# ASSESSMENT REPORT

# STAGE 1 OF MONTEFIORE AGED CARE FACILITY MP 10\_0044 MOD 2

This report is an assessment of a request to modify the Stage 1 Project Approval (MP10\_0044) for the expansion of the Sir Moses Montefiore Jewish Home aged care facility at Randwick.

Figure 7: the top floor of the Concept Approval (left) and the proposed modification including setbacks in response to FEAR 8 (right) (Base source: MP10\_0188 MOD 2 and the subject modification application)

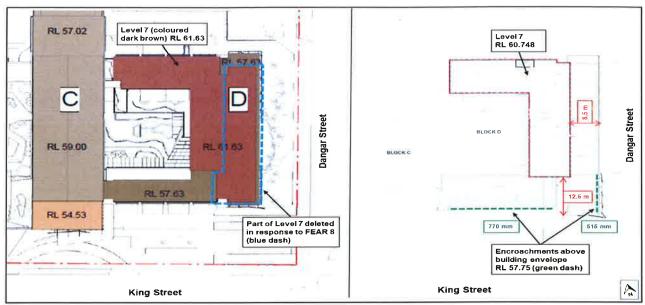
The top floor of Building D would have a maximum height of 60.748 m which is 1.78 m lower than the maximum height permitted under the Concept Plan. It will consist of plant which has been set back from the building edge so it would not be visible from the street, in accordance with the Concept Approval requirements (as shown at **Figure 7**).

The Department therefore considers the proposal is acceptable as it is consistent with ToA 6 and FEAR 8 and would not result in any unreasonable visual impacts.

Figure 8: Modified King Street (top) and Dangar Street (bottom) elevations and the location of height encroachments (Base source: the subject modification application) NSW Government

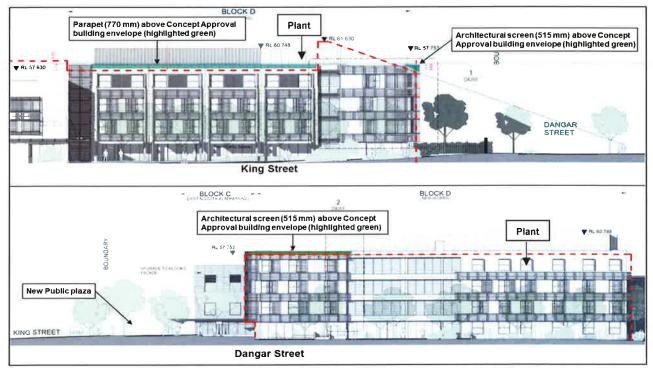
The proposed modification includes the following minor height encroachments above the building edge height limit (RL 57.75) at the building edge fronting King and Dangar Streets:

- 515 mm fronting Dangar Street, comprising a light weight architectural/façade screen
- 770 mm fronting King Street, comprising the building parapet.

The non-complying sections of the proposed modifications to the building are highlighted in green in Figures 7 and 8.

Concern was raised in public submissions and by Council about the proposal exceeding the Concept Approval height at the building edge and the visual impact of the building.

The Proponent states the 770 mm height exceedance along the King Street frontage is below the maximum approved height of Building D (under the Concept Approval) and adjoining Building C and is minor in nature. The 515 mm exceedance along the Dangar Street frontage extends less than a third of the façade, is lower than the maximum building envelope height established by the Concept Approval (RL 61.63) and forms part of the architectural expression of the building.

The Department considers the 770 mm and 515 mm encroachments above the RL 57.75 height limit for the edge of Building D are acceptable as:

- the building is setback 19.5 m from King Street and 10 m from Dangar Street and when viewed from the street, the encroachments are minor and are unlikely to be noticed
- the proposed building edge heights are lower than the Project Approval building edge heights as shown at **Table 2**
- the architectural screen fronting Dangar Street is contained within a relatively small proportion of the overall facade
- the architectural screen and the metal parapet are lightweight constructions that are architecturally integrated into the overall design of the building.

The Department also considers strict compliance with the building edge height control established under the Concept Approval would not result in any significant improvements in terms of the building's overall design and appearance. In light of the above, the Department considers the proposed building heights fronting King and Dangar Streets are acceptable and would not have an adverse impact on the surrounding area, appear overbearing or visually dominant.
